# Broadcast Products Technical Bulletin 20-2007-052

SUBJECT: HORIZONTAL LINES SKEWED ACROSS SCREEN

MODEL: **BVM-A14F5A**  
**BVM-A14F5M**  
**BVM-A14F5U**  
**BVM-A20F1A**  
**BVM-A20F1M**  
**BVM-A20F1U**  
**BVM-A24E1WA**  
**BVM-A24E1WM**  
**BVM-A24E1WU**  
**BVM-A32E1WU**  
**BVM-A32EWM**

**Figure 1**

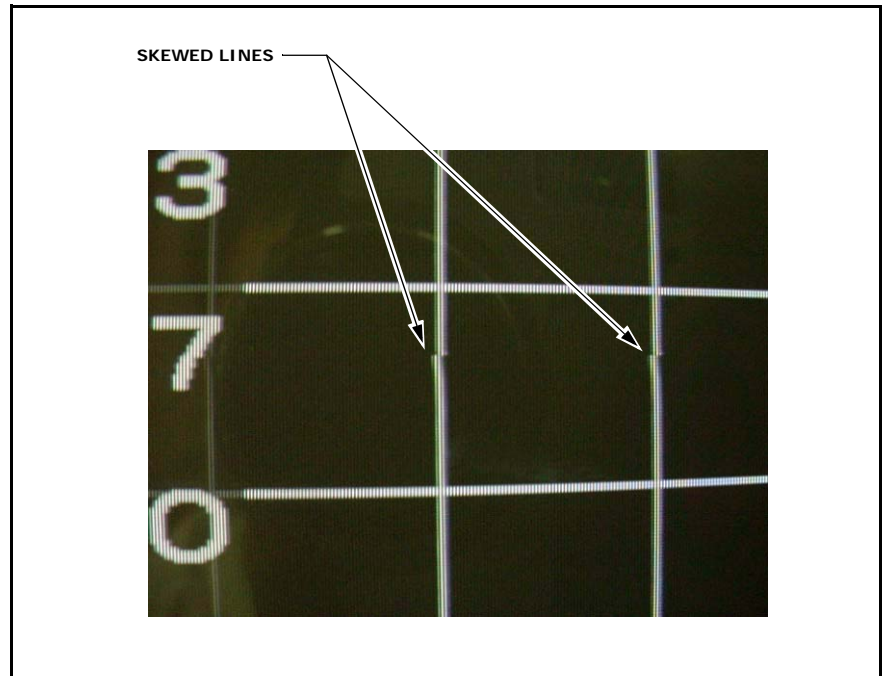
When receiving a 720/50P or 720/60P signal, one or two horizontal lines may be skewed across the entire the screen. (See Figure 1.)

The symptom occurs after the unit is warmed up, particularly with BVM-A20F1 units.

*Figure 2*

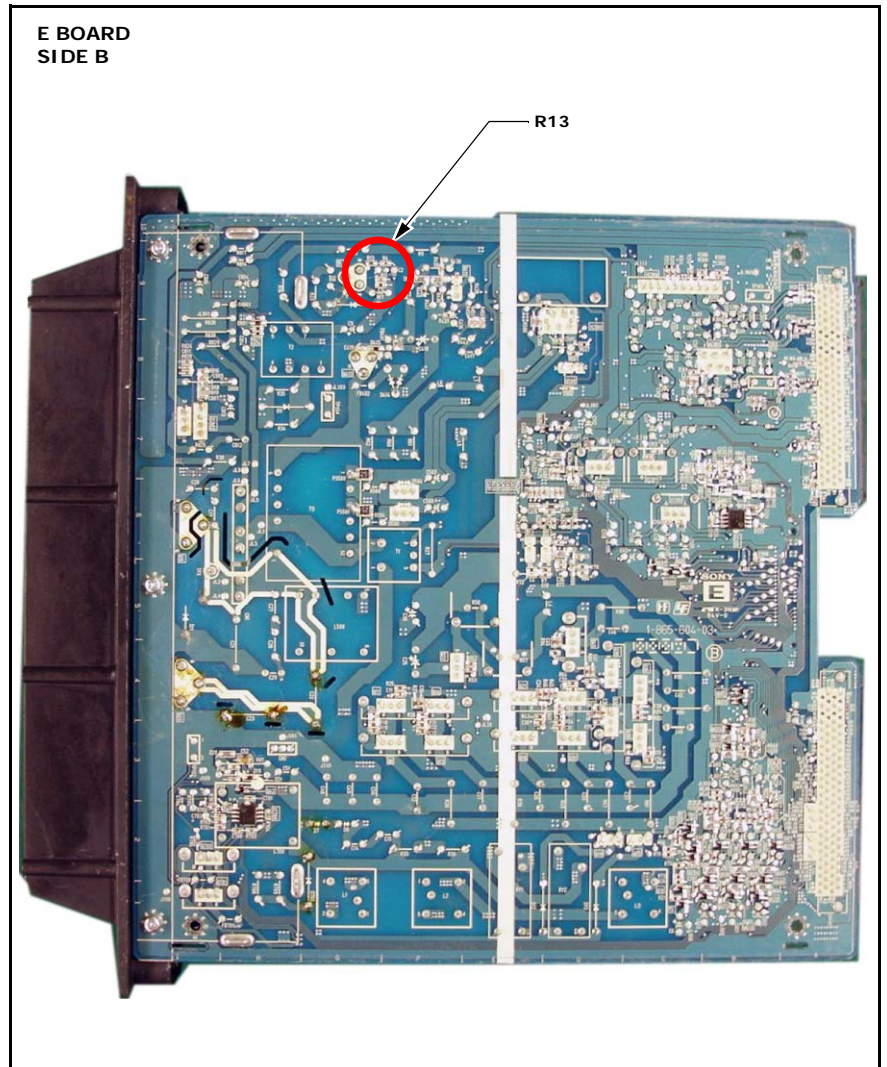
### E Board (Side B, Zone F-9)

Replace R13 (100Ω) with a new 220Ω resistor. (See Figure 2.)
